STAFF REPORT: 6/8/2022 MEETING PREPARED BY: D. RIEDEN

APPLICATION NUMBER: #22-7854

VIOLATION NUMBER: #566 ADDRESS: 17664 MANDERSON

SCOPE: REPLACE WINDOWS (WORK COMPLETED WITHOUT APPROVAL)

Photo 4: Phot showing new windows

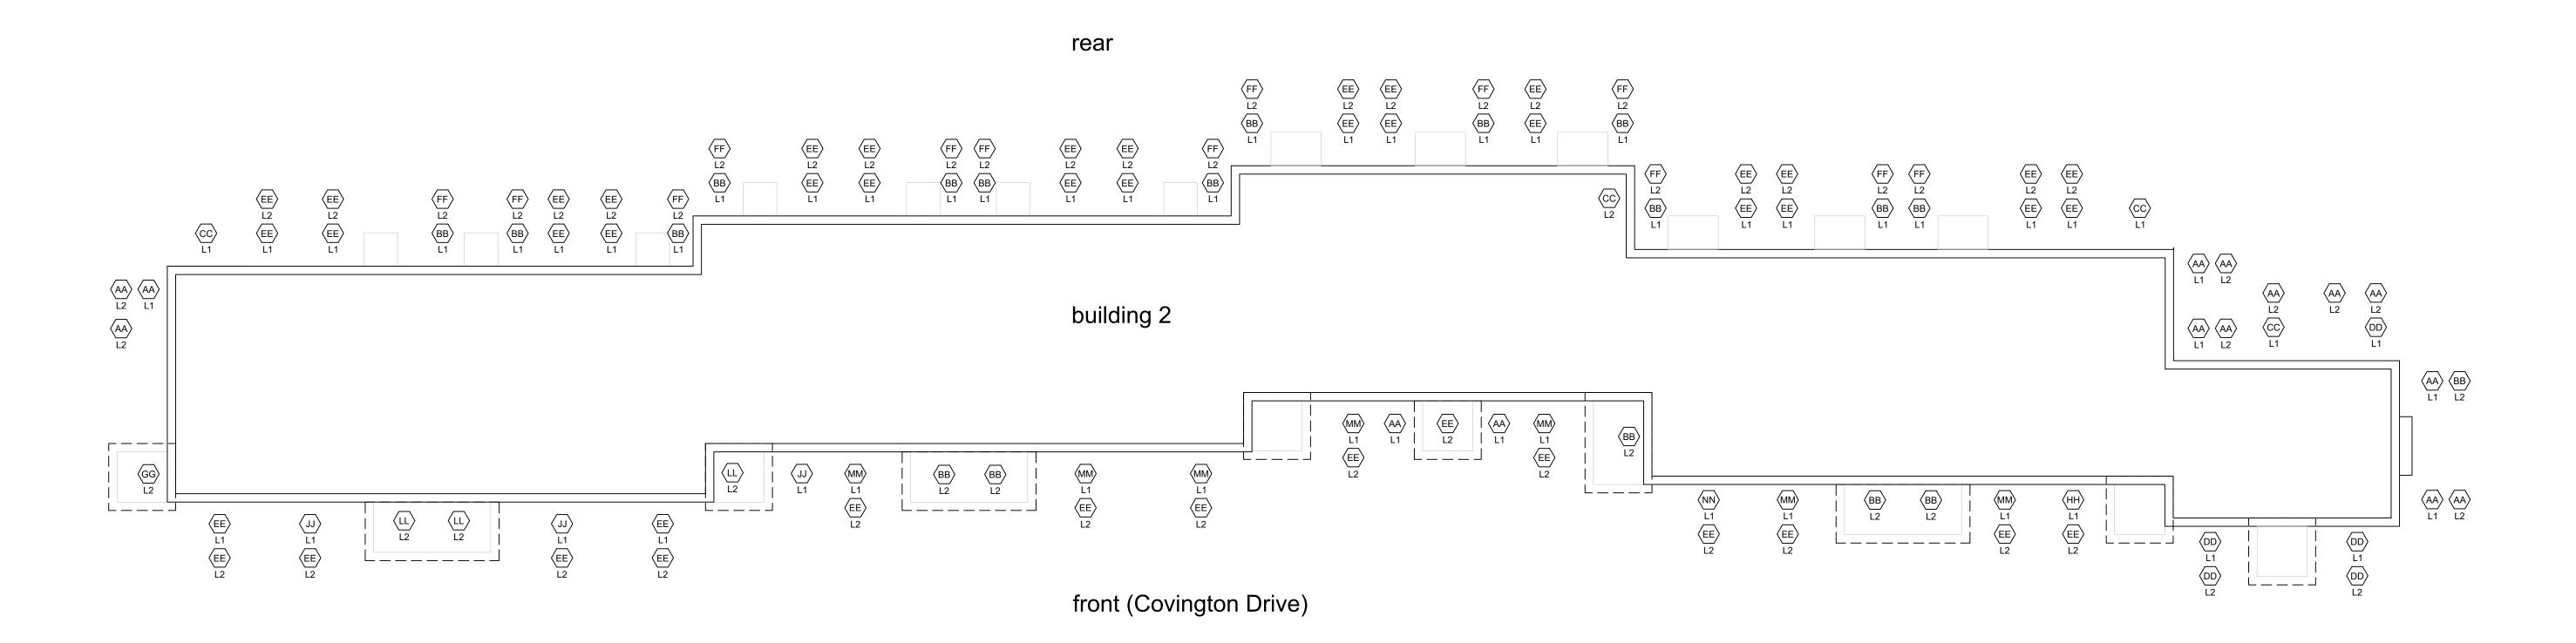
- single hung flanking windows in Building 2). All windows have no true divided lights, but instead have grilles between the glass.
- The applicant states in their proposal that the upper pane grille pattern (between the glass) was to "match" the original windows. However, staff observed that the original double-hung windows had 4/4 configuration, whereas the installed grille pattern is 6/1.
- Staff has the opinion that the original wood windows with true-

- divided light were distinctive, character-defining features that was lost when replaced with one-over-one, between the glass grille, vinyl windows.
- Staff believes that most original windows were double-hung, 4/4 wood frame windows as evident from previous photos.

- Staff identifies that both the removal of wood windows and the installation of vinyl windows are inappropriate as they introduce a material and design that destroys the historic character of the property (Standards 2 and 3), removed distinctive features (Standard 5), does not match the old character-defining feature of the original windows (removed without permit) in design, texture, and other visual properties (Standard 6).

- Staff identifies that the original 4/4 and divided light casement windows of the front elevation and courtyard, which is in public view (See photo 1), especially contribute to the character defining features of the townhouses. This character is lost in the current vinyl windows now installed.

Staff therefore recommends that the Commission issue a Denial for the above work items, as it does not meet the Secretary of the Interior's Standards for Rehabilitation, specifically Standards:

2/A100 building 2 - covington drive window plan

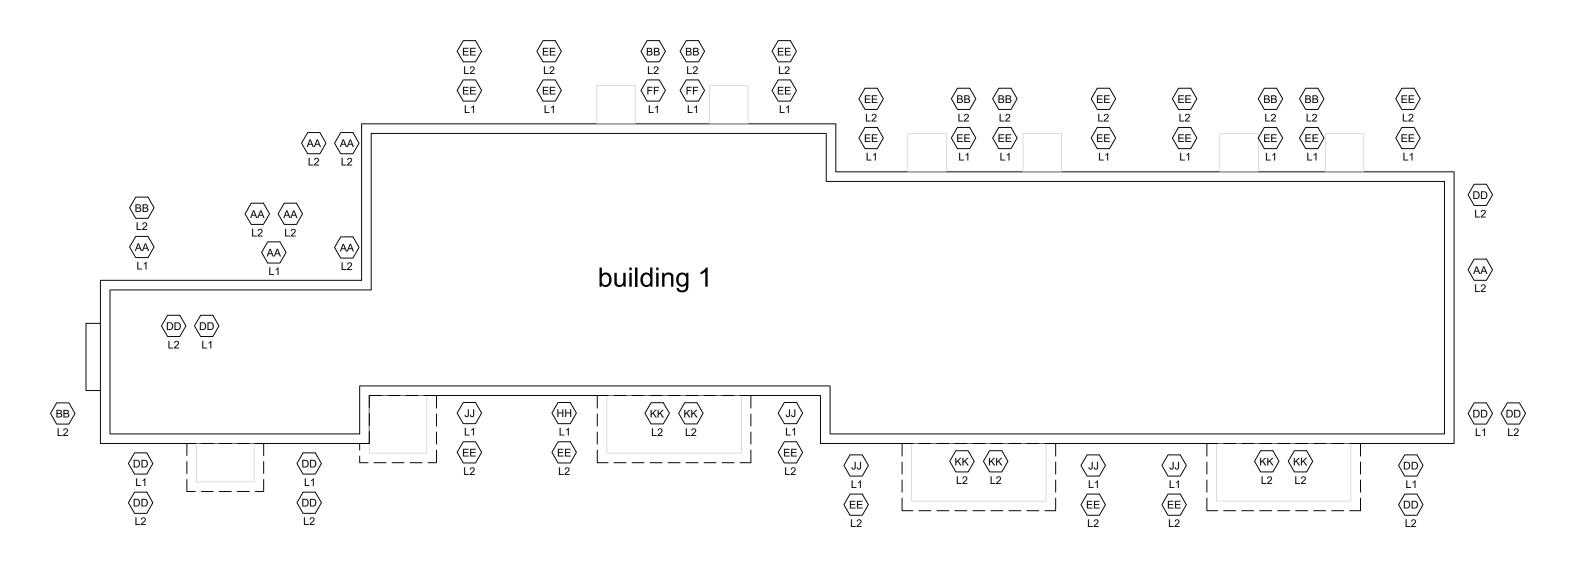
• According to the applicant's provided window schedule, Building 1, facing Manderson Drive has a total of 63 windows replaced. Building 2, facing Covington, has total of 117 windows replaced. All 180 windows are vinyl, Manchester Series by Quaker, color earthtone with matching aluminum brake metal surrounds. Most windows (170) are double-hung (6 casements in Building 1, 3 casements and 1 picture with (2)
